# RECORD OF TECHNICAL CHANGE

Project/Job Name Project Shoal

**Fluid Management Plan for the Project Shoal Area Off-Sites Project**

Fluid Management Plan for the Project Shoal Area, Off-Sites Project (DOE/NV-542, Rev. 0, April 1999)

Figure 1 Predicted 99% capture zone confidence levels for HC-5 and HC-7.

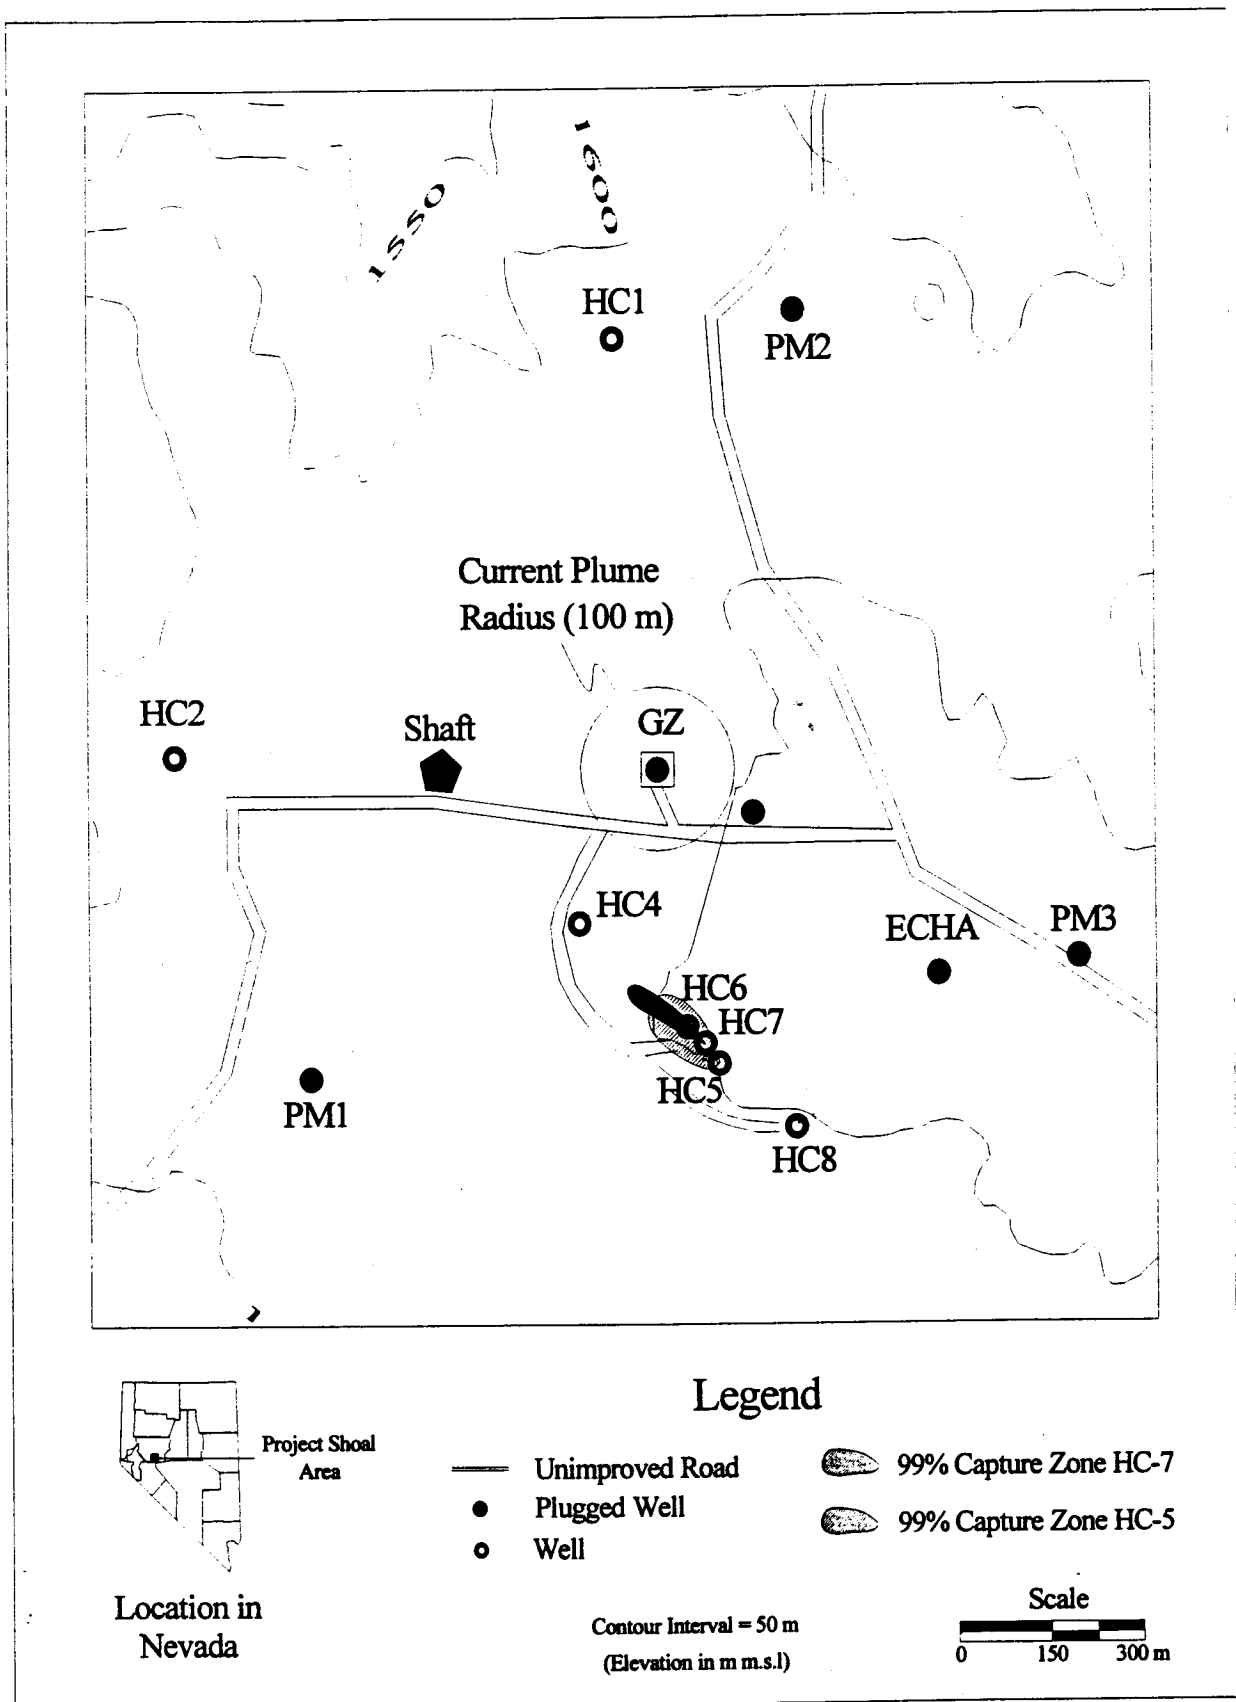
Section 4.1 of the Fluid Management Plan (FMP) specifies that monitoring for tritium shall be conducted every four (4) hours during the aquifer development and testing phase. Well HC-5 has required more time to develop than predicted. Based on current pumping rates, it is estimated that an additional 28 days will be required before the well is fully developed. Tritium monitoring results to date do not demonstrate an upward trend in tritium activity or give any indication that tritium levels will exceed FMP action levels. This technical change will nullify the requirement to collect and analyze tritium monitoring samples for the remainder of the aquifer testing at the HC-5 well. Therefore, the only action required at HC-5 will be collection and analysis of a representative sump sample in accordance with Section 4.2 of the FMP, prior to discharge to the infiltration basin.

Section 4.1 of the FMP also specifies a weekly tritium monitoring frequency for wells involved in the tracer experiment. Based on a revised wellhead capture zone analysis and initial pumping test results, it is predicted that wells involved in the tracer test will not yield groundwater in excess of FMP parameters. This technical change will nullify the requirement to collect and analyze weekly tritium monitoring samples for the remainder of the tracer test. As with well HC-5, the only action required at the wells involved in the tracer test will be collection and analysis of a representative sump sample in accordance with Section 4.2 of the FMP, prior to discharge to the infiltration basin.

Figure 1 shows the 99% confidence level for the simulated capture zone. The 99% confidence level is indicative of the worst case scenario in terms of potential migration of test related solutes toward the pumping wells.

Of the 100 realizations, none showed capture zones that intersected the calculated location of the radionuclide plume associated with the PSA test.

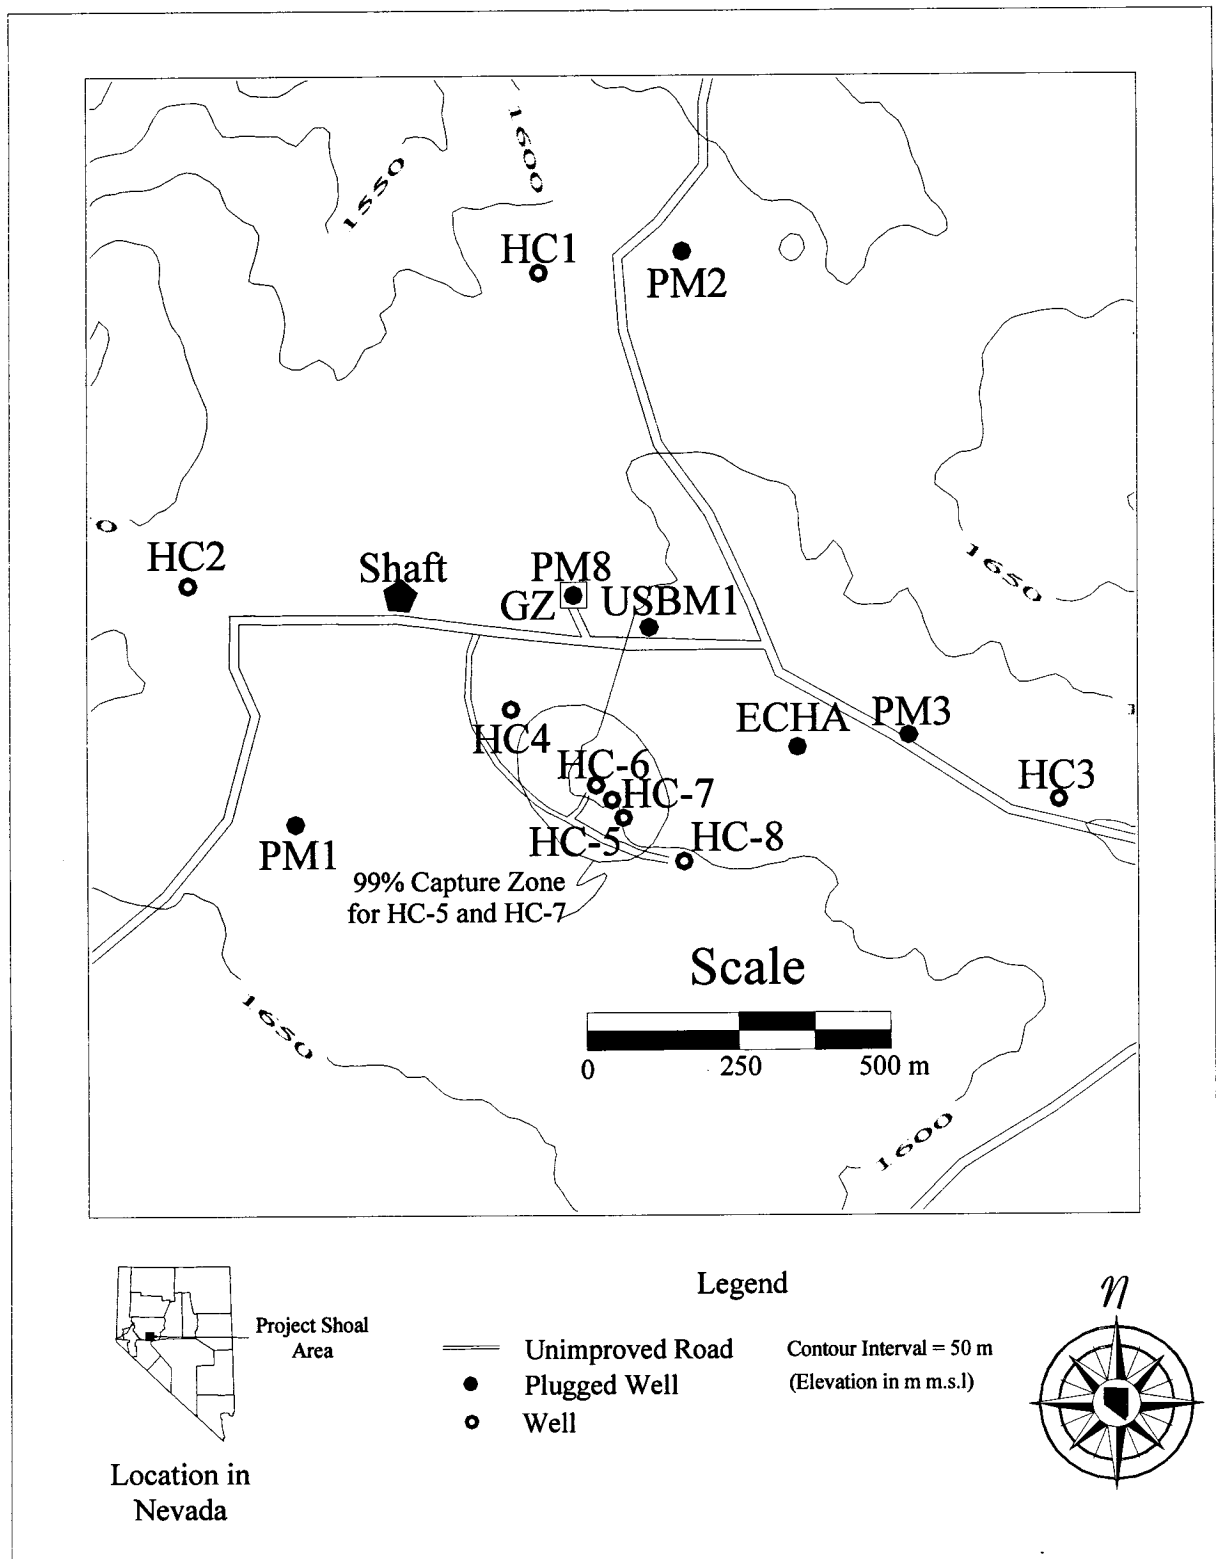
4. An analysis was performed to predict the capture zones for flow to local pumping wells. The results provide a 99% capture zone for one year's worth of pumping at two local wells (HC-5 and HC-7). This capture zone does not intersect the nuclear test (see attached capture zone analysis). The analysis is considered conservative in several ways, a principal one of which is the fact that pumping at HC-5 has now been stopped, so that the modeled pumping rate is more than twice as large as what will be incurred for the remainder of the tracer test.

Figure 1 shows the 99% confidence levels for the simulated capture zones assuming one year of continuous pumping. The capture zones for HC-5 and HC-7 merge creating essentially one larger zone. The capture zone created in this analysis is larger in the transverse direction due to the relatively larger hydraulic conductivity value as compared to previous analyzes. Although it is unlikely that pumping will continue for a total of one year, the analysis, suggests that it is still highly unlikely that test related solutes will be drawn into either HC-5 or HC-7 within one year.
